Road Safety Audit
Stage 1
for
PROPOSED MIXED USE DEVELOPMENT
AT
NEWTOWN, DROGHEDA, CO LOUTH

Report produced by: Road Safety Matters

Reference: RSM/MOB/080719/NEWTOWN RSA1

Client	Waterman Moylan Consulting Engineers
Project Title	Proposed Mixed use Development, Newton, Drogheda, Co Louth
Document Title	Stage 1 Road Safety Audit
Document Ref.	RSM/MOB/080719/NEWTOWN RSA1
Status	FINAL

Figure 3¹

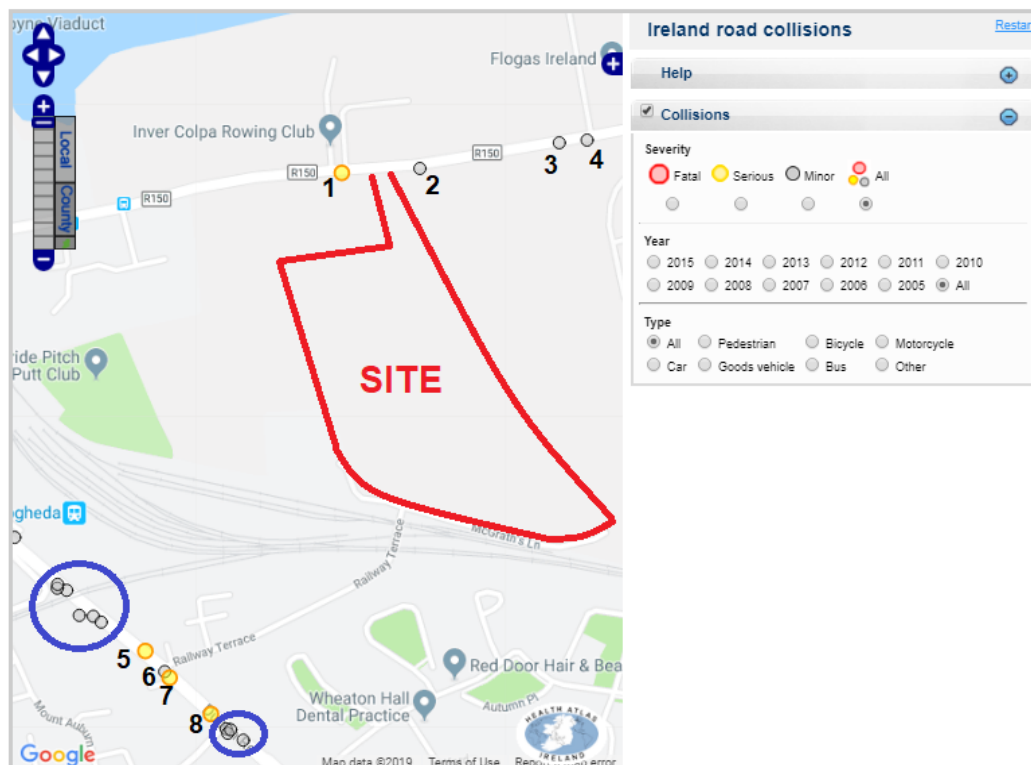
2.1.3 No information was provided on any existing collision statistics in the vicinity of the site. A review of the Road Safety Authority (RSA) online collision database indicates that there were a number of collisions recorded on the R150 in the vicinity of the proposed development site access between 2005 and 2015 inclusive, at the locations shown in figure 3, including a serious collision. There were a number of serious collisions also recorded at the intersection of Railway Terrace and the R132 Dublin Rd to the south of the site, with two additional clusters noted to the north and south of this location, as highlighted in figure 3. A summary of the characteristics of the collisions numbered 1-8 in figure 3 have been included in Table 2.

A cursory overview of the collisions characteristics indicates that there was a significant proportion resulting in high casualty severity, and a significant portion involving single vehicle collisions only, which can be indicative of inappropriate vehicular speeds. Two of the recorded collisions involved VRUs (Vulnerable Road Users – i.e. cyclists and pedestrians) and two of the recorded collisions involved a bus. Table 2 does not include an examination of the collision clusters recorded further north and south of the junction with Railway Terrace on the R132, however it is recommended that any potential safety issues on this link should be considered as the site design progresses, as the link and proposed shared surface on Railway Terrace is likely to be used by a relatively high proportion of VRUs travelling to and from the site and Drogheda town centre, including the railway station. It should be noted that the RSA database is not a comprehensive record of collisions, and should be reviewed in conjunction with the Local Authority / Gardaí records for the site, to include an investigation into installation criteria for the speed camera.

Figure 9

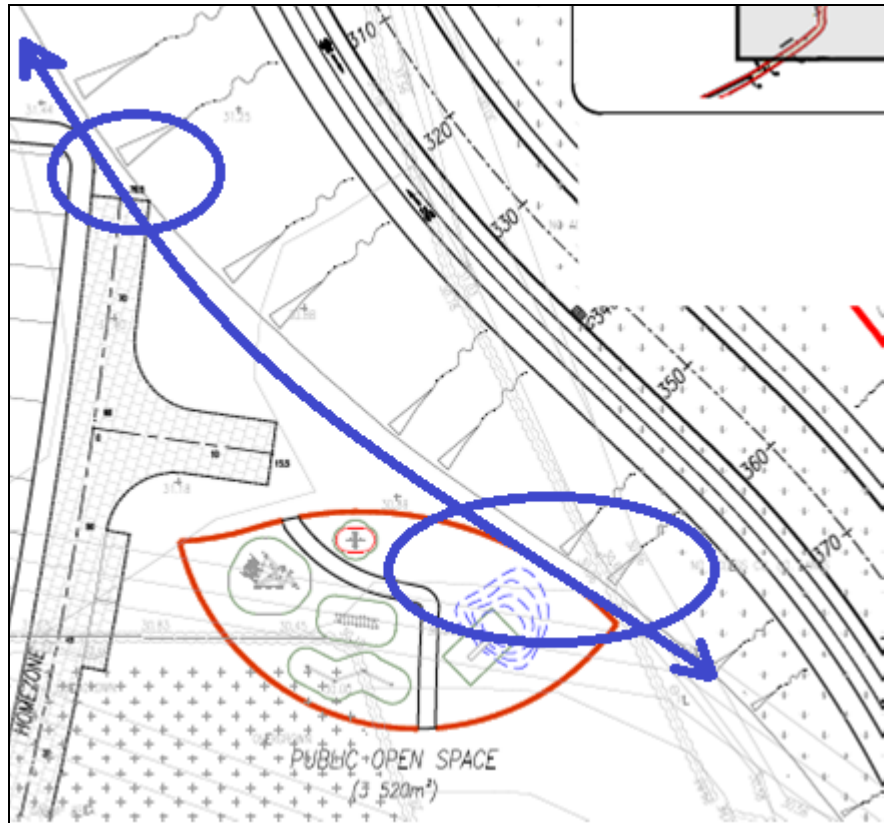
There were no details provided for proposed landscaping/boundaries within the site and along the site boundary, and no details were provided on slopes for proposed earthworks, where embankments adjacent to the proposed playground and at the ends of relatively steep links may present a hazard to vehicles and VRUs, and where there is no provision for suitable fencing or vehicle restraint, as shown in figure 9. The provision for boundary treatment along the south of the site, to prevent vehicular access/parking, as shown in figures 11 and 12, is not clear, and the provision for boundary treatment along the widened section of Railway Terrace adjacent to the steep embankment at the railway line is also unclear.

Dense hedging and overgrown verges are currently located along a significant proportion of the site boundary on the R150 and along McGraths Lane, with some overhanging trees and vegetation on the R150 on approaches to the site leading to the potential for slippery conditions on the adjacent carriageway and footways, as well as reduced conspicuity at the proposed access onto the LIHAF, particularly the large mature tree highlighted in figure 13, which is located relatively close to the carriageway edge.

Inappropriately located landscaping or boundaries exceeding 1.05m in height along the site frontage or along any of the links throughout the site, particularly in the vicinity of junctions or

Landscaping proposals should be clarified at detailed design stage, with all trees and landscaping to be located away from positions which could increase the risk of conflict or have a negative impact on intervisibility at VRU desire lines, or where shedding leaves may cause slip/trip hazards. Proposed or existing landscaping and boundary treatments throughout and surrounding the site, should be located outside visibility splays or provided at a height less than 1.05m above ground level. Internal boundaries, walls and landscaping should also be offset a safe distance from the edge of carriageway, and forward visibility and stopping sight distance on all links throughout and surrounding the site should be clear and unobstructed in accordance with traffic speeds. Earthworks proposals to be clarified at detailed design stage to include details of slope and heights, with provision for suitable fencing and vehicle restraint where necessary throughout the site. Demands for vehicular access from the south should be assessed to determine suitability of access proposals and requirements for boundary treatment.

table has also been added at the first junction from the LIHAF road entrance.		
2.1.6 Problem - Earthworks, Landscaping and Fencing / Boundary Treatments	Yes	Landscaping proposals have been provided by Ronan MacDiarmada & Associates Ltd as part of the SHD submission. Appropriate VRU desire lines and visibility splays will be facilitated. Earthworks proposals will form part of the detailed design. Demands for vehicular access to the south of the site will be very low, with access to the 2 No. existing properties only. No vehicular access to the proposed development area will be provided from the South.		Yes

Figure 12

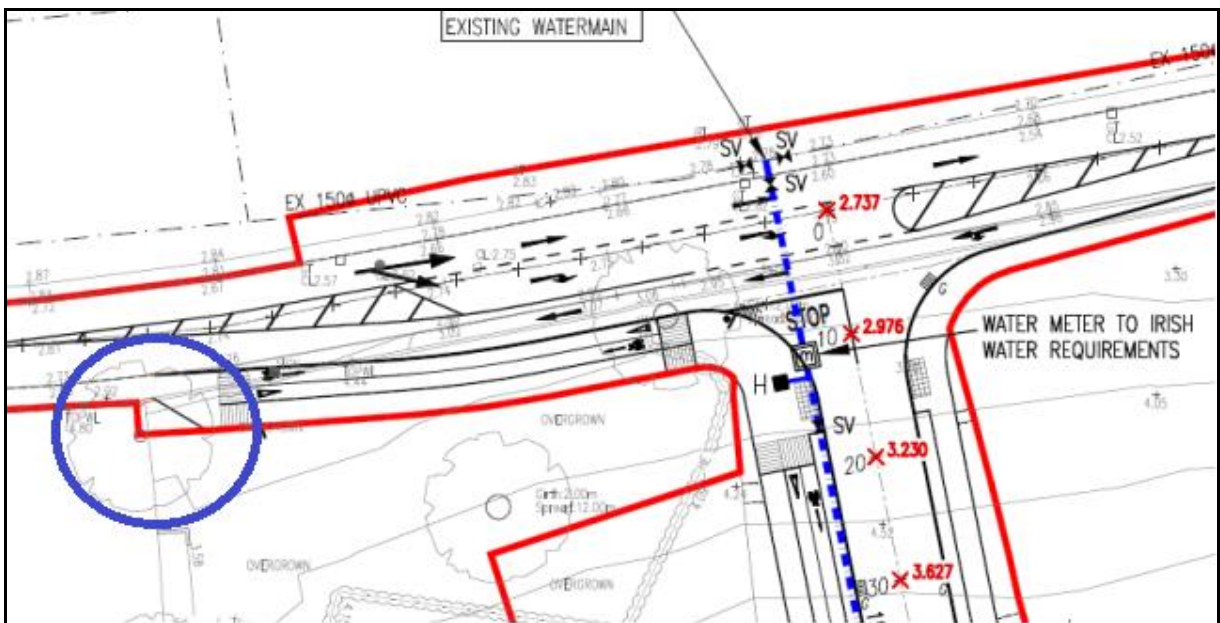
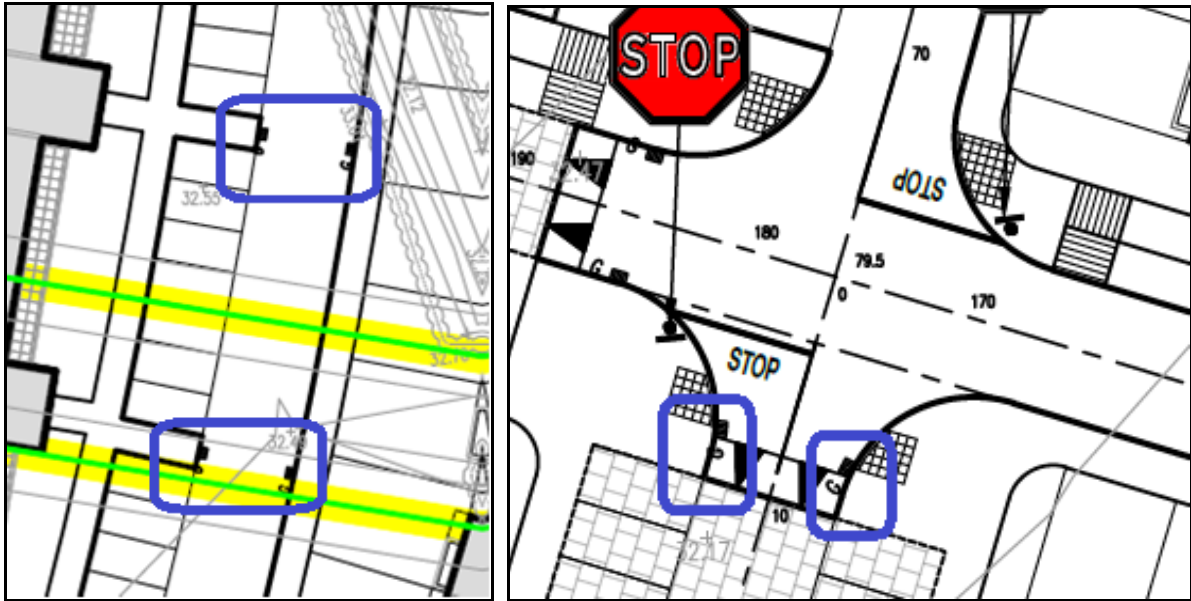
curved sections of road, may compromise visibility splays and sightlines, and may compromise intervisibility between pedestrians or motorists, or to and from vehicles reversing from perpendicular parking spaces within the site. Trees and landscaping located adjacent to pedestrian routes and footways can cause slippery conditions due to fallen leaves and can also compromise street lighting.

Figure 26

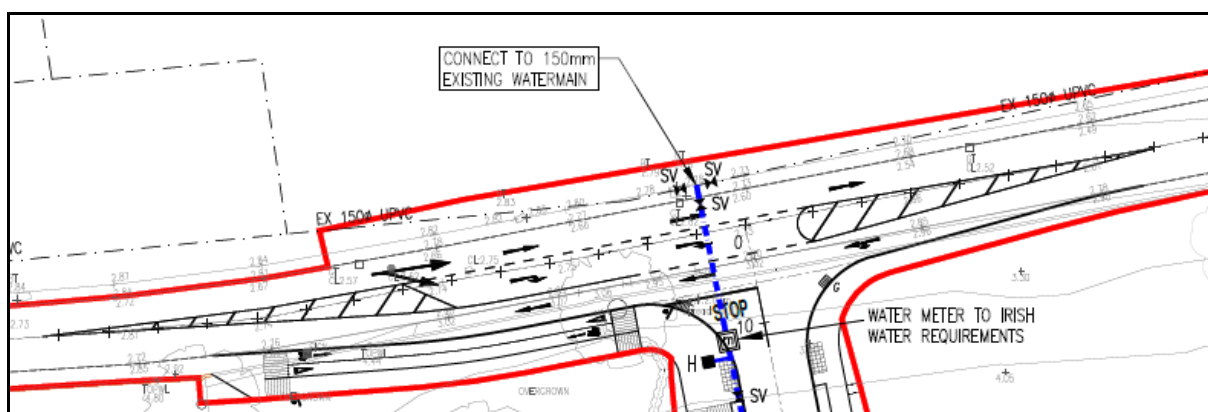
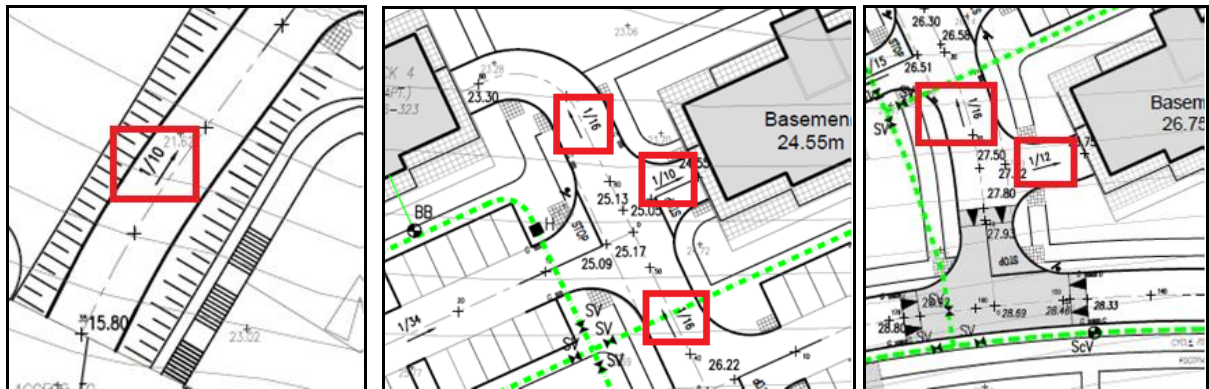
There was no information provided on existing and anticipated traffic volumes to determine any potential safety issues arising from the proposed geometry for each of the access junctions into

the site, as well as all internal junctions. The design for the access off the R150 includes provision for a right turn reservoir into the site, as shown in figure 26, through which all vehicular access will be achieved, although the provision for vehicular access to the south of the site is unclear, as outlined previously in paragraph 2.1.6. It was noted that there are proposals for committed development immediately southeast of the site (133 units) which will also require access from the same junction off the R150.

A TTA should be produced for the site to show the cumulative impact of all committed developments in the locality, and to demonstrate that the proposed geometry of all junctions will accommodate anticipated turning movements and vehicle sizes. The Designer should demonstrate that the total demand for right turners into the site off the R150 is satisfied by the proposed right turn reservoir length, and that traffic queuing to enter the development site will not obstruct the movement of through traffic on the regional road. The lane widths at the new access junction should also cater safely for all anticipated vehicle sizes, including HGVs and two wheeled vehicles. The minimum length of right turn reservoir should ideally be at least 35m, to allow for deceleration and suitable taper, with a longer length and taper required for higher approach speeds, and the reservoir length increased to allow for queuing traffic. The demand for right turners out of the junction should also be assessed in conjunction with examination of the AADTs on the major road, to determine any issues arising in respect of increased risk of right angled collision, with queuing vehicles within the reservoir obstructing visibility towards the left, towards vehicles approaching in the nearside lane eastbound.

2.1.11 Observation - Cumulative Traffic Volumes and access junction proposals	Yes	A traffic and transport assessment (TTA) has been prepared as part of the subject application and is available under separate cover. The junctions have been designed to accommodate anticipated flows. There is no vehicular access to the south of the site from McGraths Lane / Railway Terrace.		Yes

Figure 30

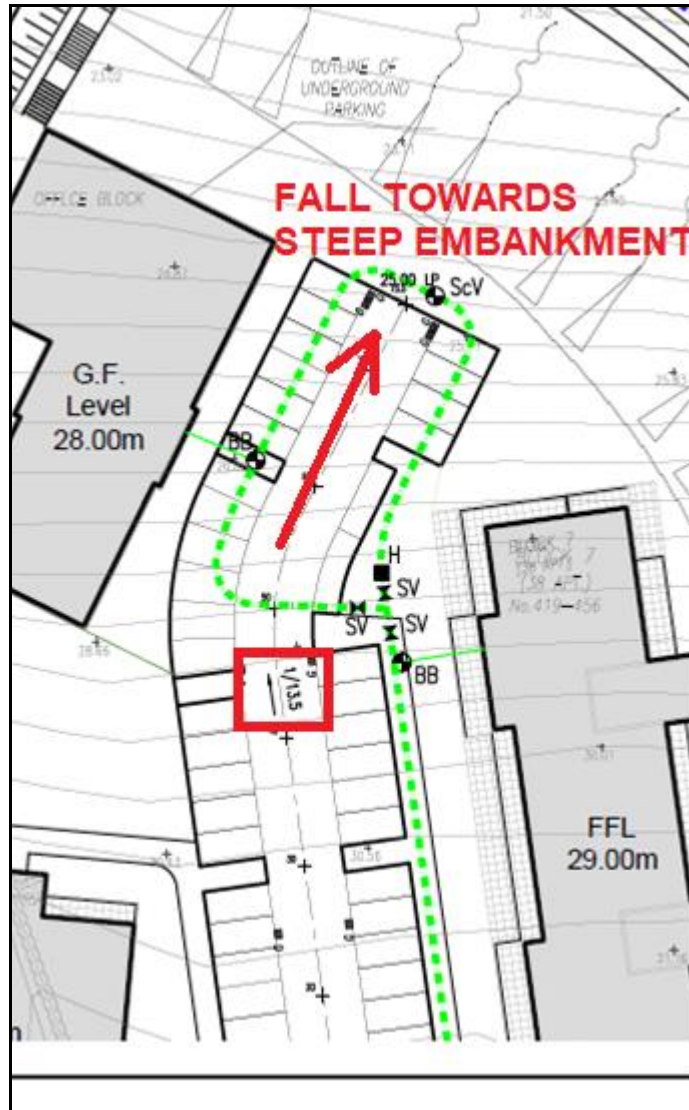
The proposed vertical alignment on the LIHAF will result in gradients of almost 7%, which will present difficulties for some vehicles and for some VRUs in wet and icy conditions. Steeper gradients were noted on a number of other links throughout the site, including gradients exceeding 10%, which is a departure from standard. Examples of such locations are shown in figures 27-30. Figure 31 shows a location where the shallow gradient may cause drainage issues, as there is no provision for gullies along the link. Steep gradients were also noted on approaches to junctions/intersection points, which increases the risk of vehicular conflict and vehicular/VRU conflict at these locations. There was no horizontal or vertical alignment design provided with the preliminary design layout to determine any issues in respect of Stopping Sight Distance (SSD).

Horizontal and vertical design proposals should be included on detailed design plans, with long and cross sections, to demonstrate that the proposed alignments will safely accommodate anticipated traffic volumes and speeds with suitable sightlines and gradients. Gradients exceeding 5% should be avoided on routes to be used by VRUs, with gradients exceeding 7% (absolute maximum 8%) to be avoided. A relatively level dwell area (2.5-3% maximum) should be provided on the approach to all junctions and access points for a suitable distance back from the stop line/channel line to minimise the risk of larger vehicles overturning or overshooting the stopline, as well as rear shunt collision risk and collision with VRUs potentially crossing junction mouths.

2.2.1 Problem - Steep gradients and alignments	Partially	Horizontal and vertical alignments to be provided as required at detail design stage. In relation to Fig. 31, drainage gullies will be provided as necessary.	Road gradients - The gradient of the LIHAF road has been approved by Louth County Council and is necessary given the natural topography. In relation to steep internal gradients, the topography of the site in particular areas results in a requirement for short sections of steep road gradients to avoid excessive earthworks. The roads have been designed to comply with DMURS which permits short sections of roads at gradient steeper than 1/20 (5%). The 1/10 and 1/12 sections are basement access ramps and comply with the relevant guidelines.	Yes ⁵

Figure 35

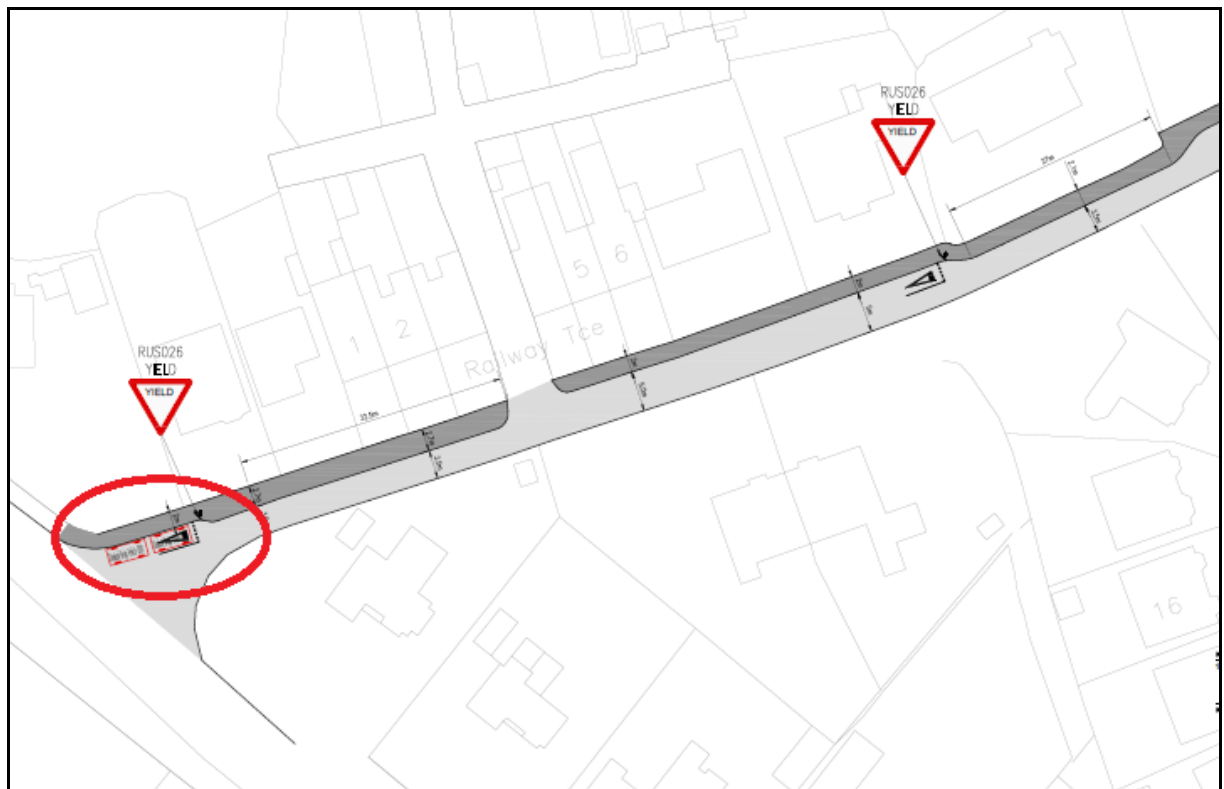
The design proposals show provision for a yield arrangement for vehicles entering Railway Terrace from the direction of the R132 to give way to vehicles exiting from the direction of the site, as shown in figure 35.

The Audit Team are concerned that there is a limited space for vehicles to wait at this location, with an increased risk of blocking back to the intersection with the R132. Visibility towards the rear of any queues forming will be compromised for vehicles travelling from the direction of the town centre (north) wishing to turn left onto Railway Terrace due to the nearside boundary treatment at this location (high wall and hedging), leading to a risk of rear shunt collision. Forward visibility towards the east along Railway Station at this point is also constrained by the vertical alignment and parked vehicles as well as the high boundary

The layout of the link should be examined along with the location of the proposed yield arrangements to ensure clear forward visibility can be provided to and from oncoming traffic at all times and towards the rear of any queues forming. Where on-street parking is compromising safe two way movement and forward visibility, parking should ideally be restricted and suitable replacement parking provided to cater for the demand. Clear signage should also be provided to limit vehicular access on this link.

2.2.4 Proposed give way arrangements on Railway Terrace	No		Louth County Council have agreed that there should be no on-street parking on Railway Terrace. There is sufficient parking for residents on the surrounding side lane ways. It appears that people using the Train Station may park along this road to avoid parking fees at the station. As outlined above, there will be no vehicular access to the proposed development along Railway Terrace / McGraths Lane. The upgrade works have been designed to improve pedestrian access along this route. Given that Railway Terrace only grants access to a small number of dwellings, and hence traffic flows are expected to be low, the 2 No. waiting spaces shown in Figure 35 are considered adequate.	Yes ⁷

Figure 45

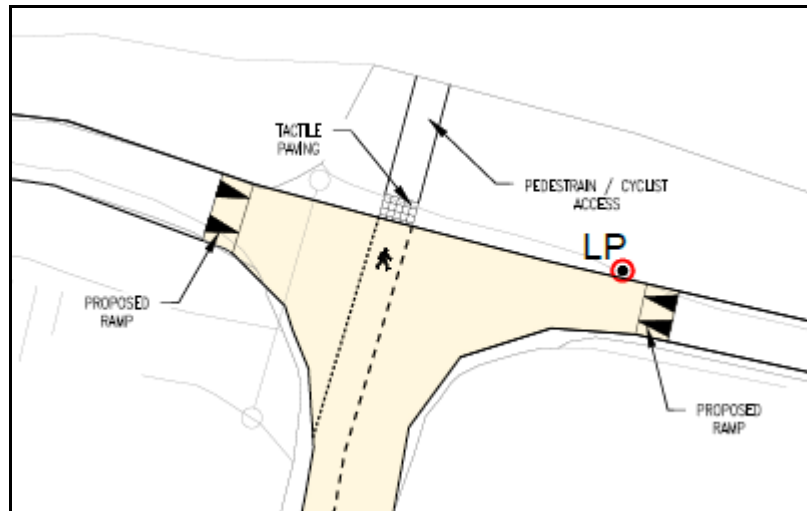
It was noted that there is no provision for guidance on the priority movement and rights of way at McGrath's Lane/Railway Terrace to the north of the railway overbridge, where sightlines are poor due to the height of the bridge walls, as shown in figure 43, and where provision has been made for pedestrians to cross the centre of the junction, as shown in figure 45. There is no provision for form of control at a number of internal junctions/intersection points, and one of the internal crossroads has been marked with a stop line on each arm, as shown in figure 46, which will lead to ambiguity and uncertainty regarding rights of way.

The priority and rights of way at all potential conflict points should be clear to all road users to prevent ambiguity and confusion, and to minimise the risk of conflict. An investigation should be made into improving sightlines in the vicinity of the railway bridge to the south of the site.

Figure 50

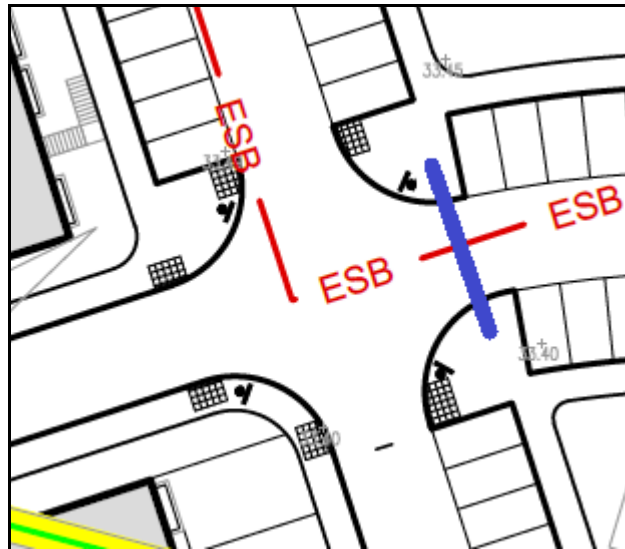
- Provision has been made for tactile paving/informal crossing points at most of the internal junctions throughout the site, however no provision has been made for dropped kerbs for the benefit of mobility impaired road users, and tactile paving is also missing from some desire lines to cross at junctions, as shown in figure 50.

Pedestrian activity, desire lines and demands should be considered both within the site, at tie-in points, and on routes used to access the site, with detailed design layout to be finalised taking into account all issues raised above. Details of all kerb heights throughout the site to be clarified at detailed design stage, with a maximum kerb upstand of 6mm to be installed on all desire lines to cross the carriageway across the path of moving vehicles, and dropped kerbs ideally flush with the adjacent road surface. Footways should be continuous, clear and unobstructed at all times, with a minimum continuous width of 2m to be provided in an urban zone, and a minimum controlled crossing width of 2.4m to be provided on the R150 subject to a review of pedestrian and vehicular volumes, to be increased to 4m if the crossing is to be shared with cyclists. All street furniture should be located to the rear of the footways where possible in a location which does not compromise the footway width to less than the absolute minimum desirable width of 1.2m on isolated sections. Overhanging trees should be cut back to minimise slip hazards arising from fallen leaves and to improve lighting conditions and VRU conspicuity. All chamber covers and gullies should be flush with the surrounding pavement and ideally located outside pedestrian and cyclist desire lines. Intervisibility at all crossing points within the site and surrounding the site should be clear and unobstructed at all times in accordance with traffic speeds.
